**ST. LUCIE PLANT
UNIT 1 AND UNIT 2**

**IMPROVED TECHNICAL
SPECIFICATIONS CONVERSION**

**ITS SECTION 3.7
PLANT SYSTEMS**

Revision 0

Figure 3.7.15-1 (page 1 of 1)

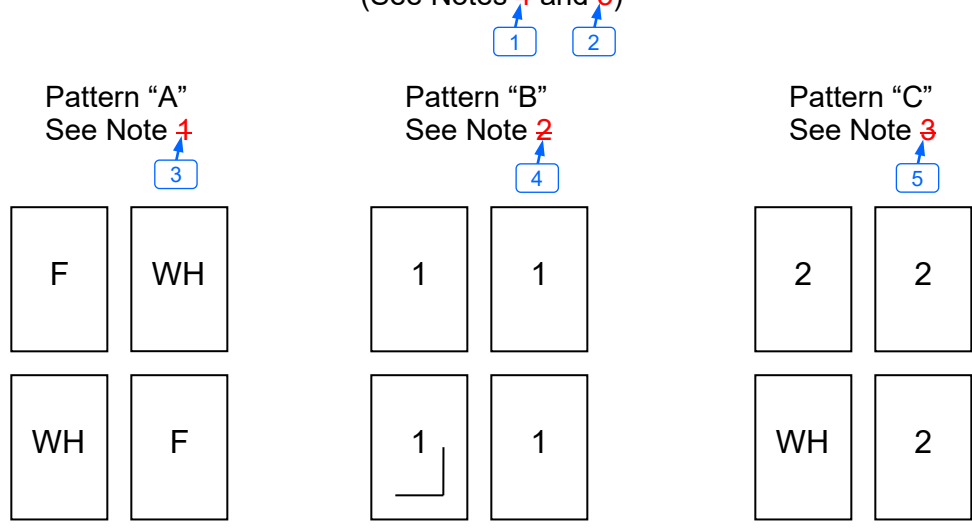
b → 2. Fuel placed in Region 1 of the spent fuel pool storage racks shall comply with the storage patterns and alignment restrictions of Figure 5.6-1 and the minimum burnup requirements of Table 5.6-1.

A01

Figure 3.7.15-2 (page 1 of 2)

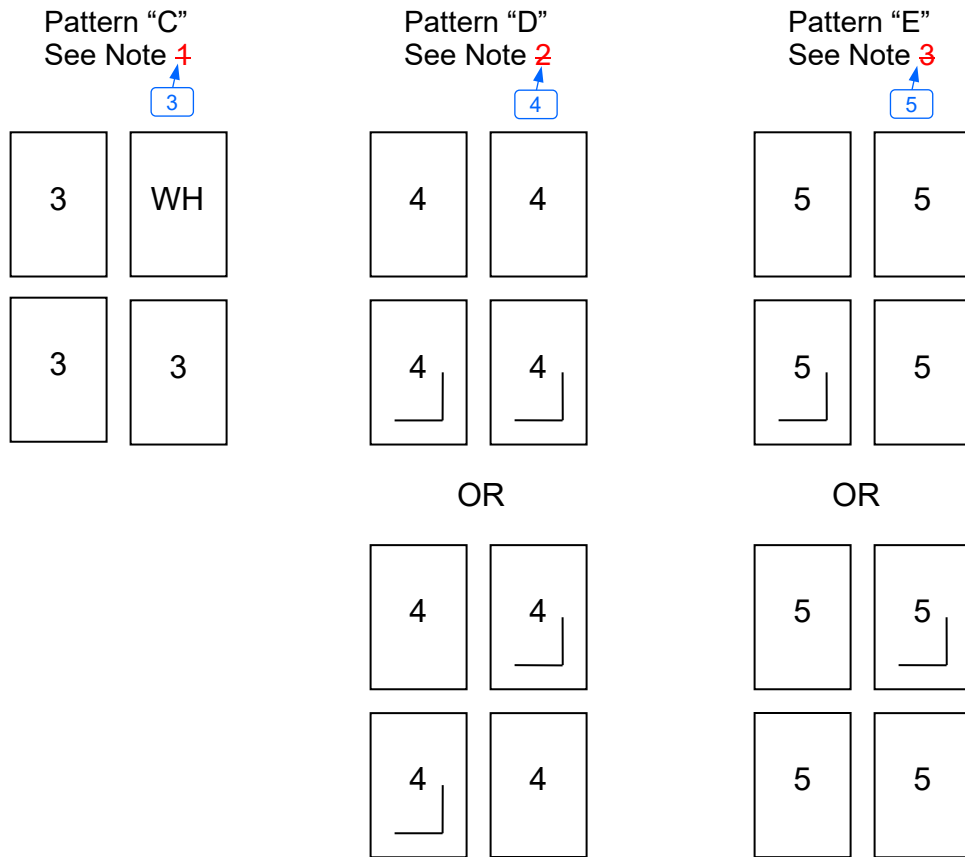
c → 3. Fuel placed in Region 2 of the spent fuel pool storage racks shall comply with the storage patterns or allowed special arrangements of Figure 5.6-2 and the minimum burnup requirements of Table 5.6-1. The allowed special arrangement for fresh fuel may be repeated, provided the applicable interface requirements specified by the safety analysis are met.

Figure 3.7.15-1 (page 1 of 1)

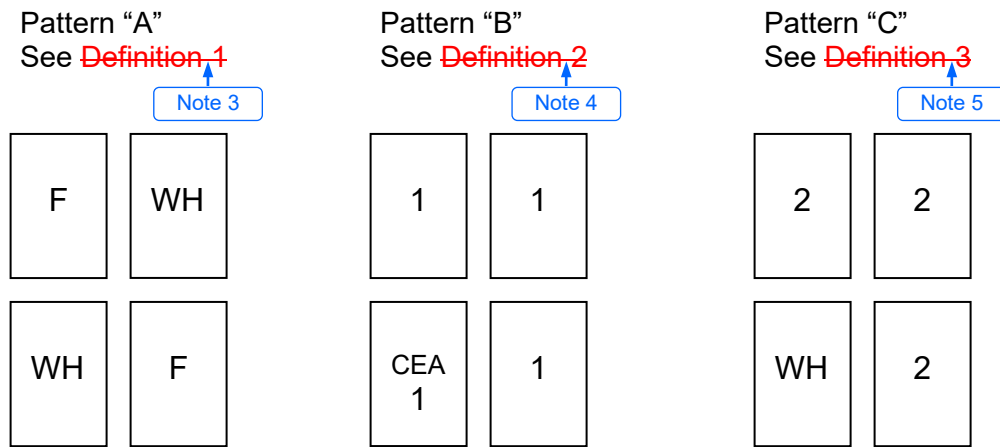
b → 2. Fuel placed in Region 1 of the spent fuel pool storage racks shall comply with the storage pattern definitions of Figure 5-6-1 and the minimum burnup requirements as defined in Table 5-6-1. (See Specification 5-6-1.c.7 for exceptions)

Figure 3.7.15-2 (page 1 of 3)

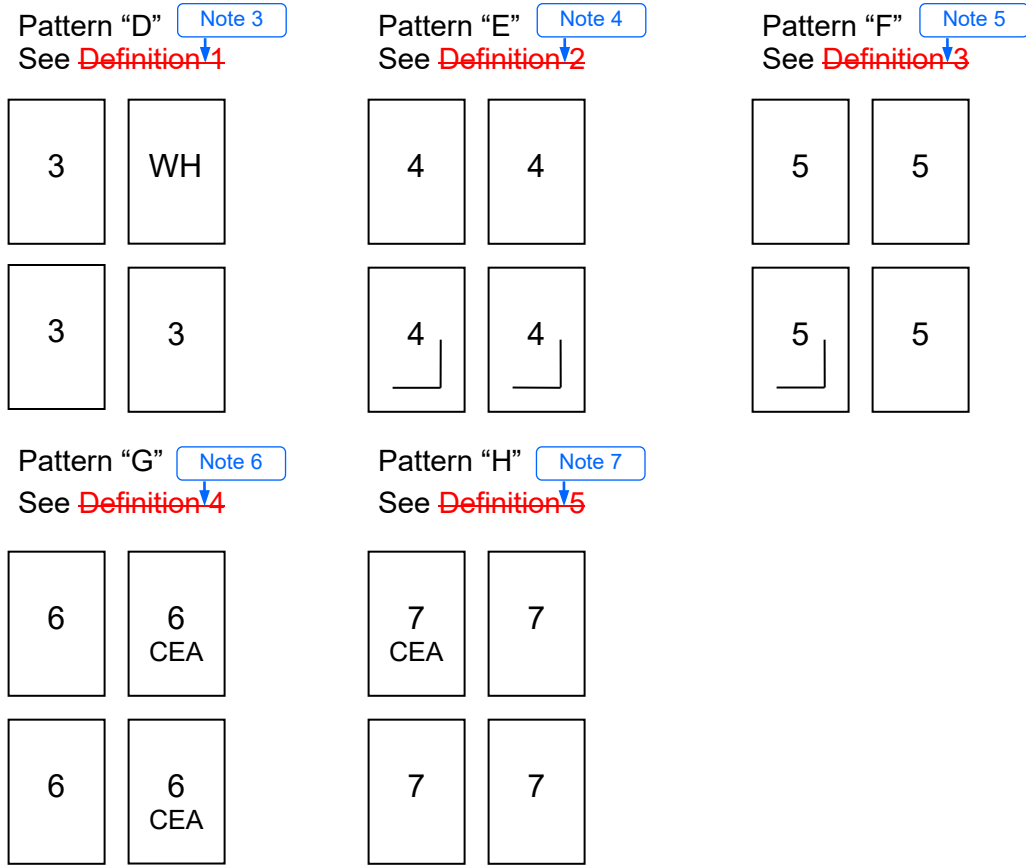
c → 3. Fuel placed in Region 2 of the spent fuel pool storage racks shall comply with the storage pattern definitions or allowed special arrangement definitions of Figure 5-6-2 and the minimum burnup requirements as defined in Table 5-6-1 (See Specification 5-6-1.c.7 for exceptions)

Figure 3.7.15-4 (page 1 of 1)

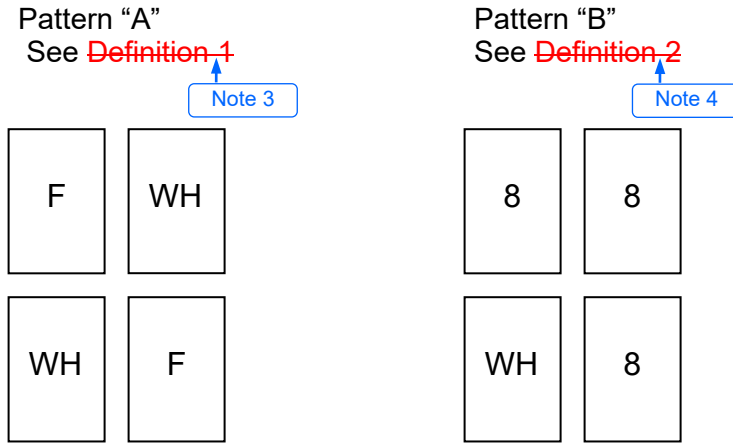
- LCO 3.7.15.e e → 5. Fuel placed in the cask pit storage rack shall comply with the storage pattern definitions of Figure 5.6-4 and the minimum burnup requirements as defined in Table 5.6-1. (See Specification 5.6.1.c.7 for exceptions)

Figure 3.7.18-1 (page 1 of 1)
Discharge Burnup vs. Initial Enrichment for Region II Racks

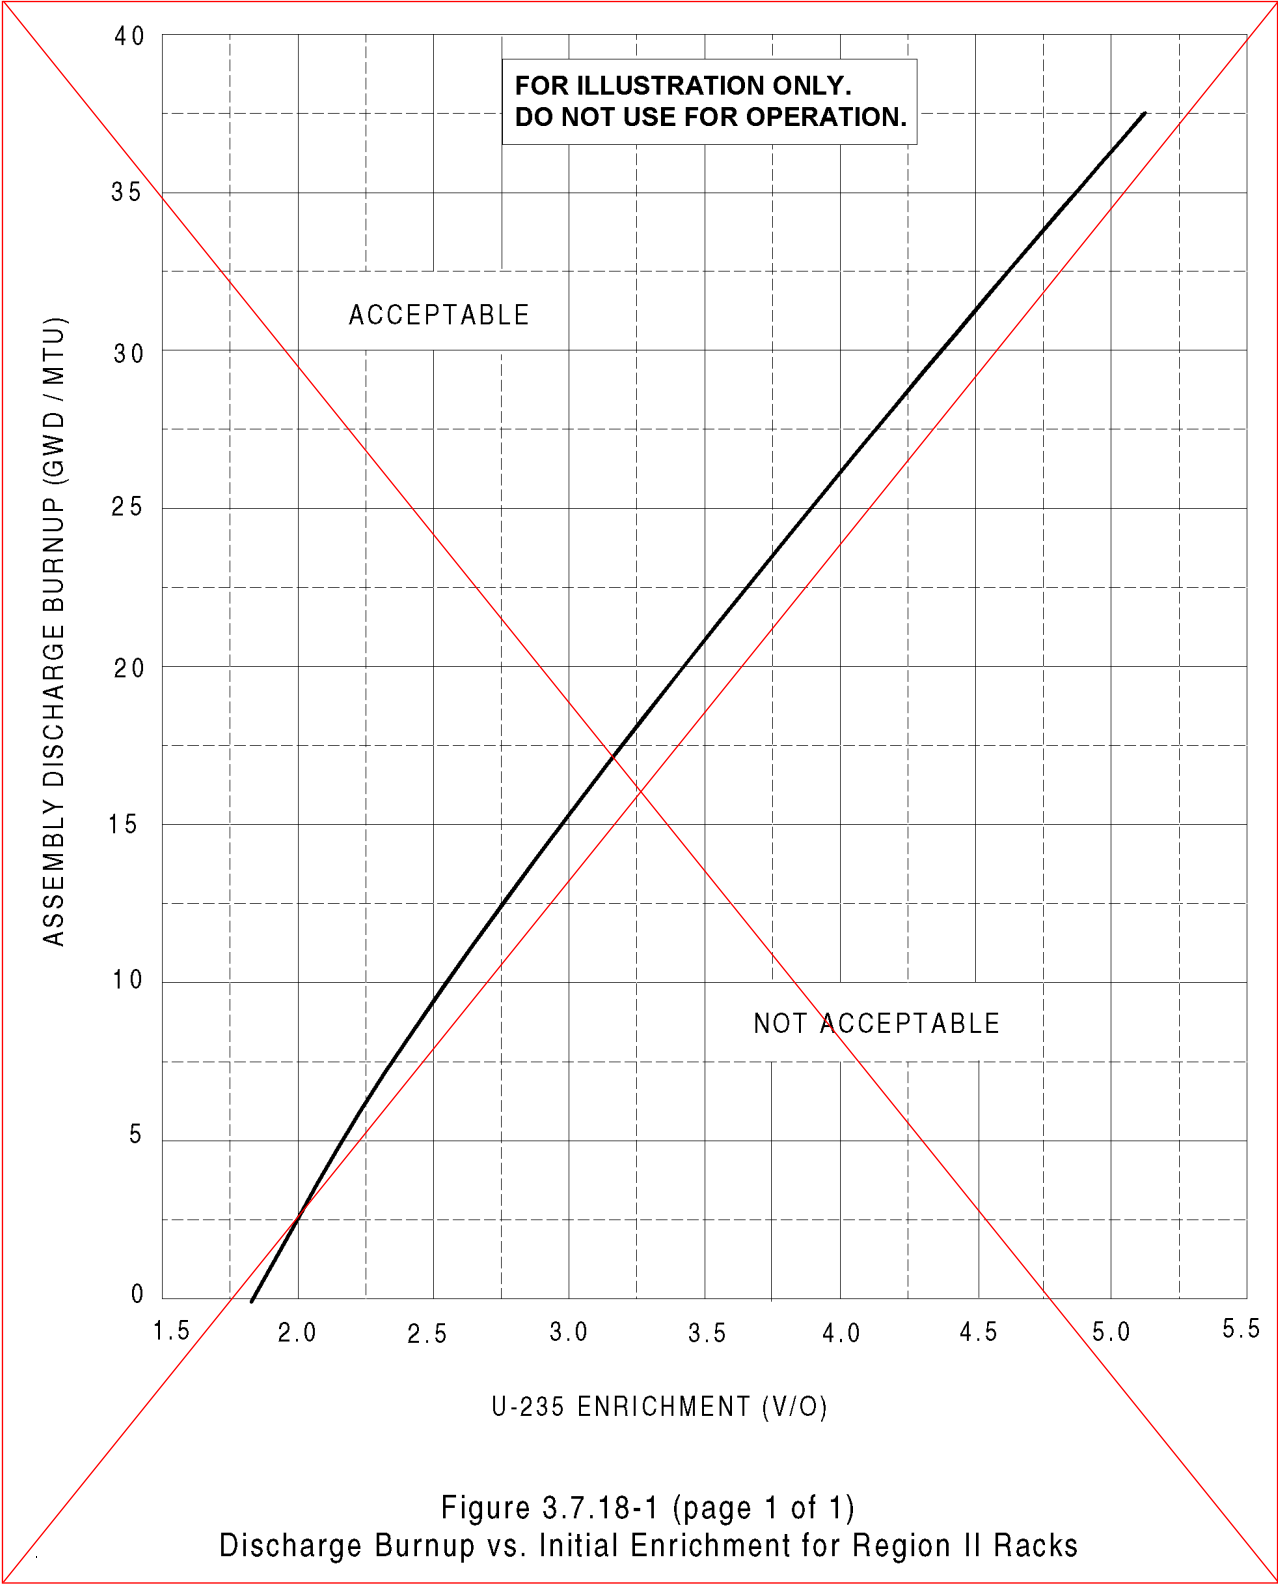
The combination of initial enrichment and burnup of each fuel assembly stored in [Region 2] shall be ~~within the acceptable [burnup domain] of Figure 3.7.18-1 [or in accordance with Specification 4.3.1.1].~~

SURVEILLANCE	FREQUENCY
SR 3.7.18.1 Verify by administrative means the initial enrichment and burnup of the fuel assembly is in accordance with Figure 3.7.18-1 or Specification 4.3.1.1.	Prior to storing the fuel assembly in [Region 2]

Insert 3 (Figure 3.7.15-1)

Insert 4 (Figure 3.7.15-2)

Insert 5 (Figure 3.7.15-3)

Figure 3.7.15-3 (page 1 of 2)
Region 2 Interface Requirements with Region 1

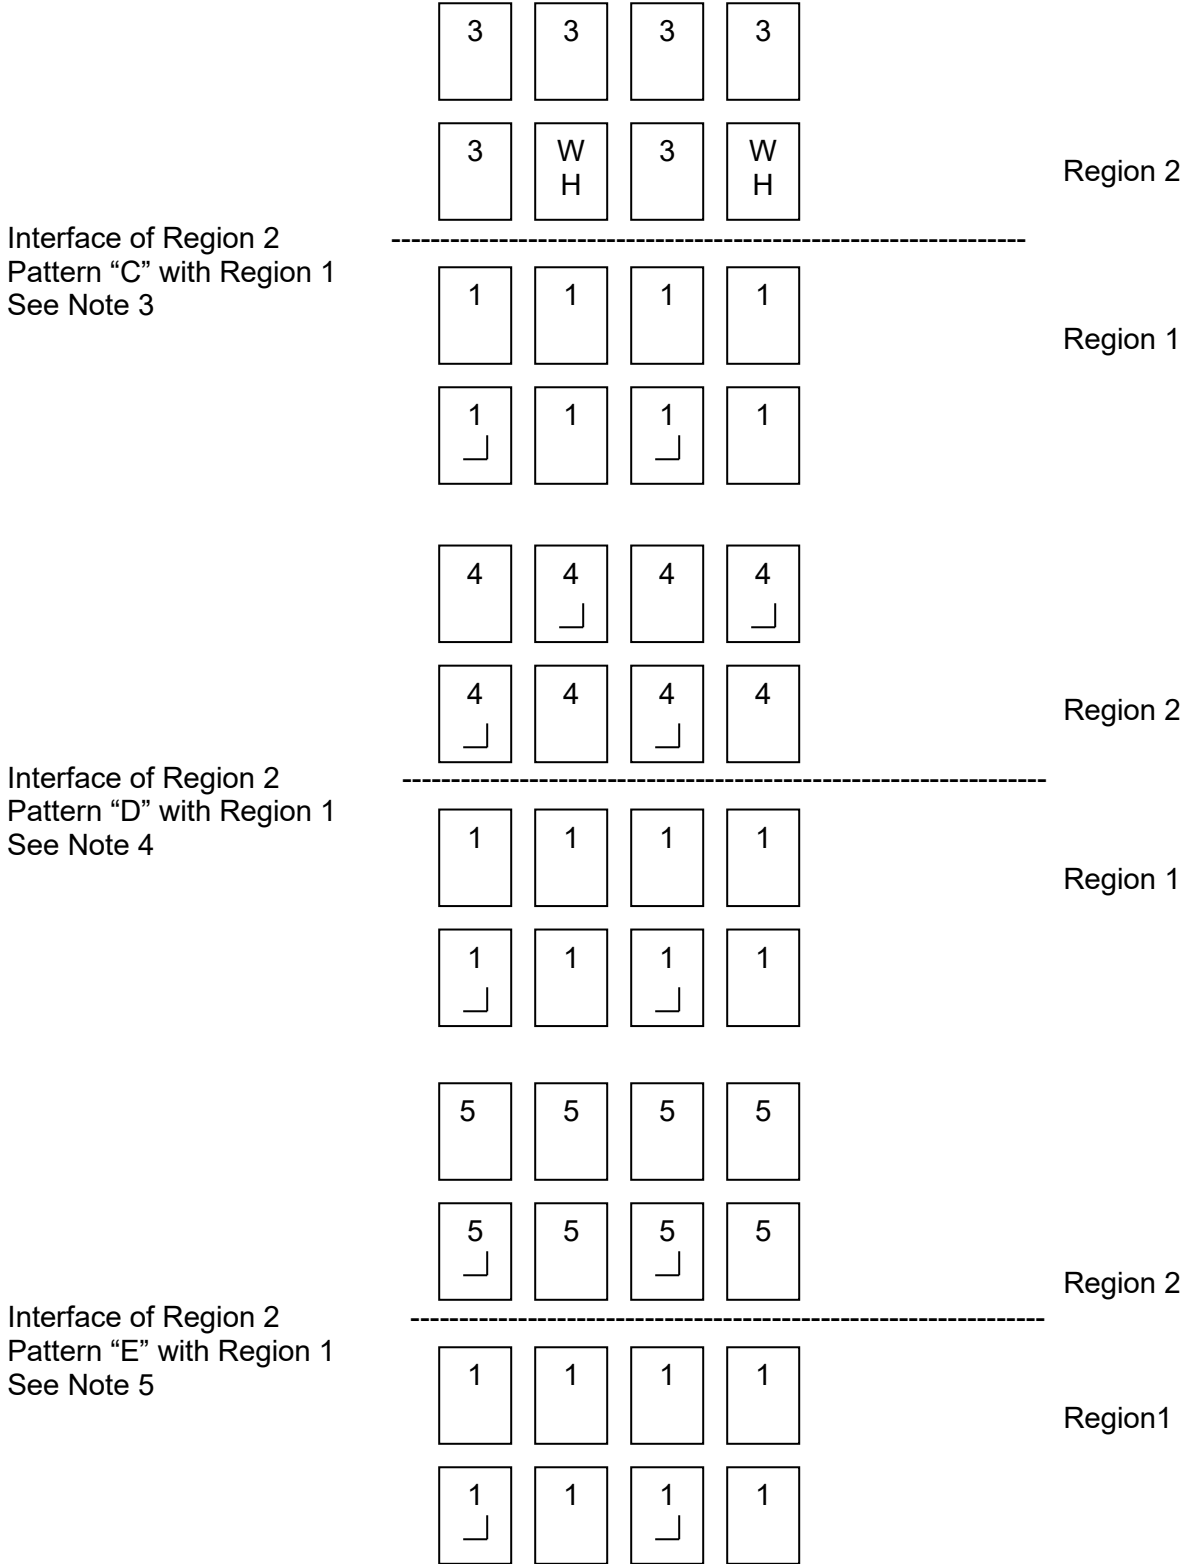
- 5.6.1.c.6 f. Any 2x2 array of Region 2 storage cells that interface with Region 1 shall comply with the requirements of Figure 3.7.15-3.

-----NOTE-----
The allowed special arrangement in Region 2 as shown in Figure 3.7.15-2 shall not be placed adjacent to Region 1.

Figure 3.7.15-3 (page 1 of 2)
Interface Requirements between Region 1 and Region 2

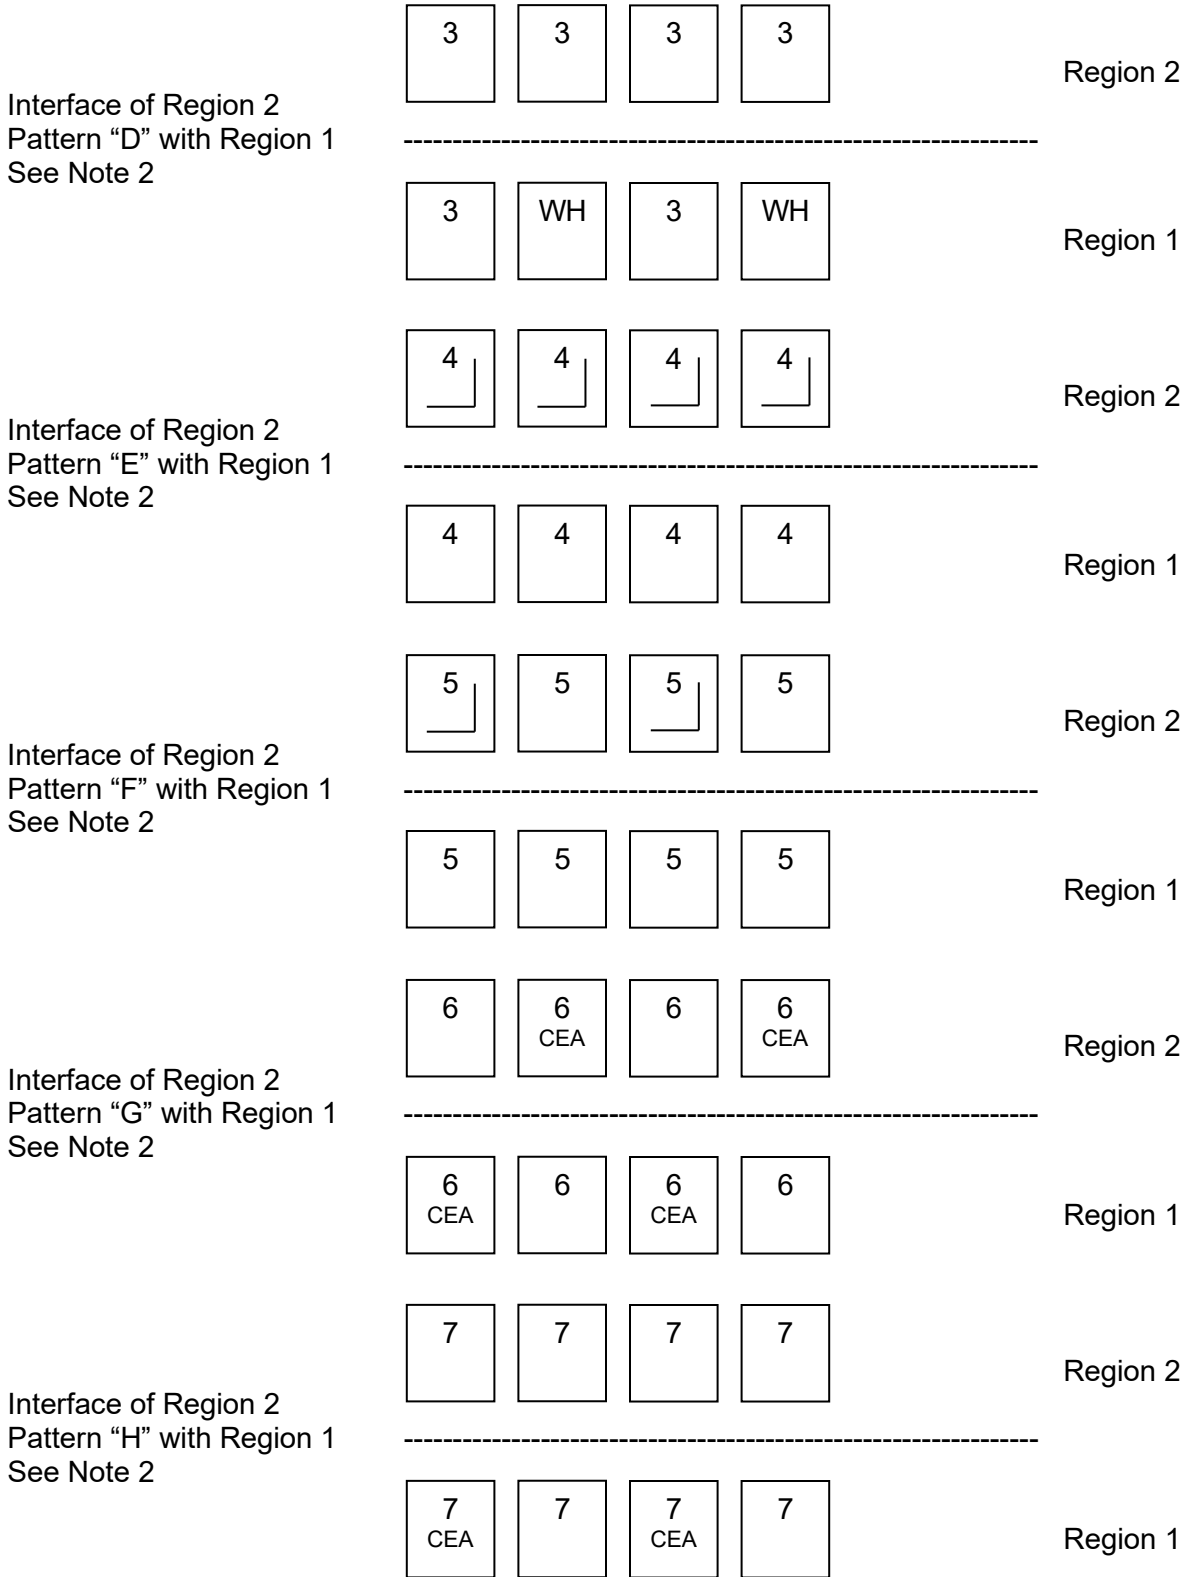
- 5.6.1.c.4 d. Any 2x2 array of fuel assemblies that span the interface between Region 1 and Region 2 of the spent fuel pool storage racks shall comply with the storage patterns of Figure 3.7.15-3 and the minimum burnup requirements of Table 3.7.15-1, except as specified in LCO 3.7.15.g;

-----NOTE-----
The allowed special arrangements in Region 2 as shown in Figure 3.7.15-2 shall not be placed adjacent to Region 1.
